Lubecore Technical Announcement

Next Generation Pressure and Low Level Switches for Pneumatic Pumps & Associated Harnesses - Overview

The images on the following 2 pages are the instruction sheet that will be included in the 13.413 harness kit.

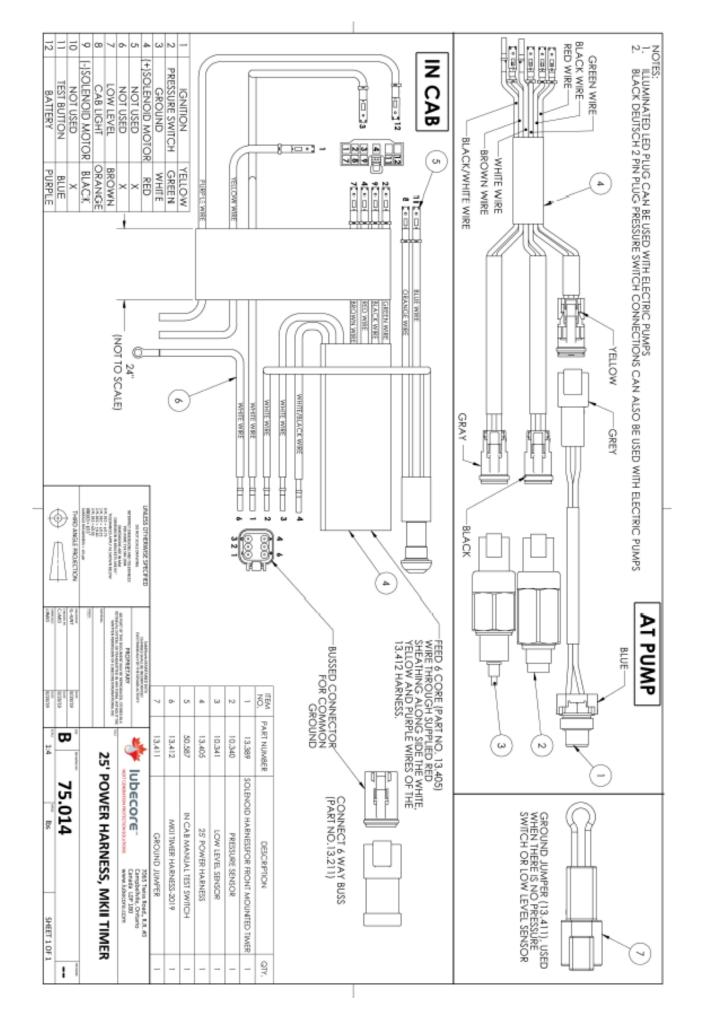
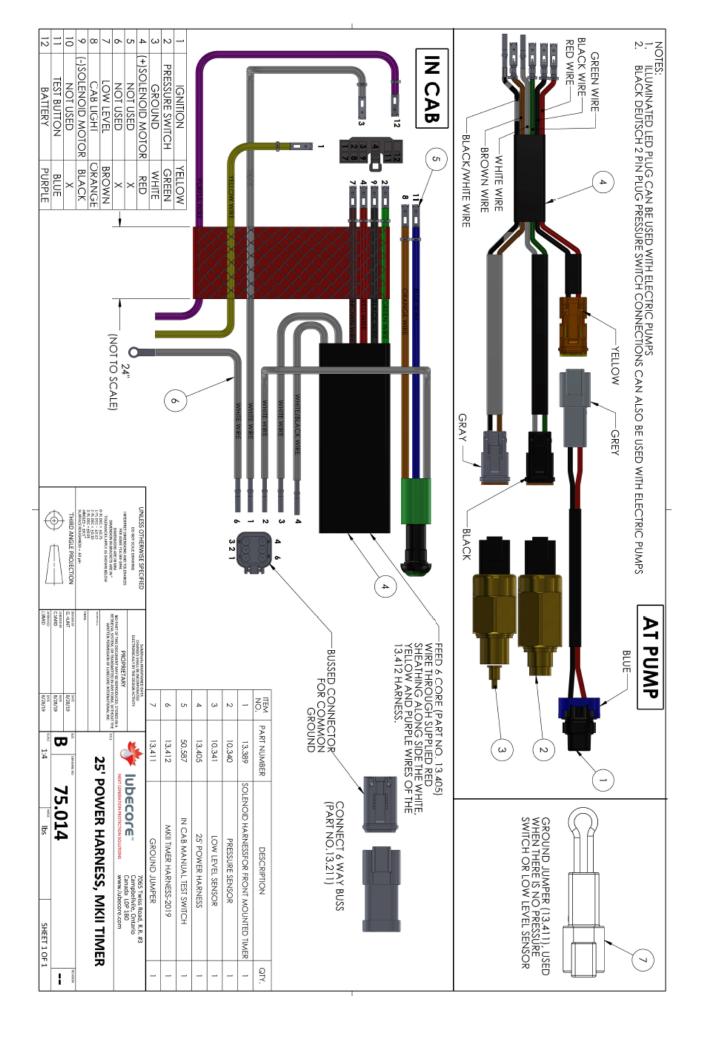
Since these switches feature a different connector, the harnesses Lubecore builds for the parallel systems are also changing.

The new harness features fewer intermediate connections near the pump. The harness will now directly terminate at the mating connectors for the pressure and low level switches. The LED function for the solenoid/motor connection remains. To make it easier to install, grey colour sheathing and connector body are used for connection to the low level switch, while black sheathing and connector body are featured for the pressure switch.

(Figure 3). This sealed loop is simple to connect near the pump at installation, and allows the pump to be updated with switches in the future.

For further clarity on the update to the wire position in the timer connector, please see the two charts below:

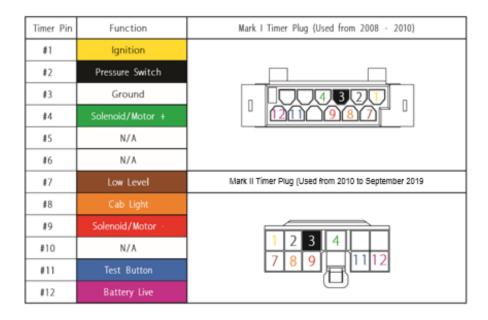
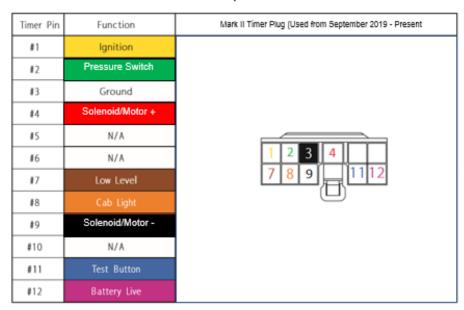
Included in the update to the harnesses is the revision of the conductor colour positions within the timer connection plug. The affected colours are as follows:

Colour	Previous Position in Timer Connector /	New Position in Timer Connector /
	Function	Function
Red	Pin #9 / Solenoid or Motor (-)	Pin #4 / Solenoid or Motor (+)
Black	Pin #2 / Pressure Switch	Pin #9 / Solenoid or Motor (-)
Green	Pin #4 / Solenoid or Motor (+)	Pin #2 / Pressure Switch

All other colours remain in connection configuration as they were in previous harnesses. The change to have solenoid/motor have red wire as positive, and black wire as negative brings conventional colour designation to the Lubecore harness, and should help to avoid reverse polarity. In order to indicate that the colour configurations for the timer plug have been updated, the sheathing for the in-cab portion of the harness is now red instead of black. (Figure 2.)
